Modifications Notices

Issue Date
October 15, 2026

20261009_PDC_00001

Notice of change in outer plating due to improvement of parts procurement

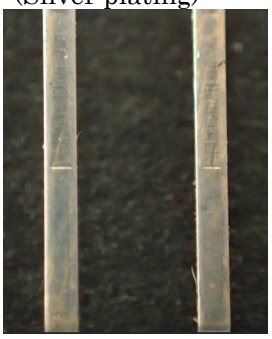
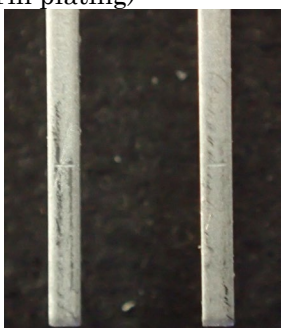
Before the change	After the change
The outer plating of the light emitting/receiving terminals will be changed. Ag plating (Silver plating)  Figure. Ag-plated terminals' color (typical example)	Sn plating (Tin plating)  Figure. Sn-plated terminals' color (typical example) No changes in soldering temperature and dimensions.
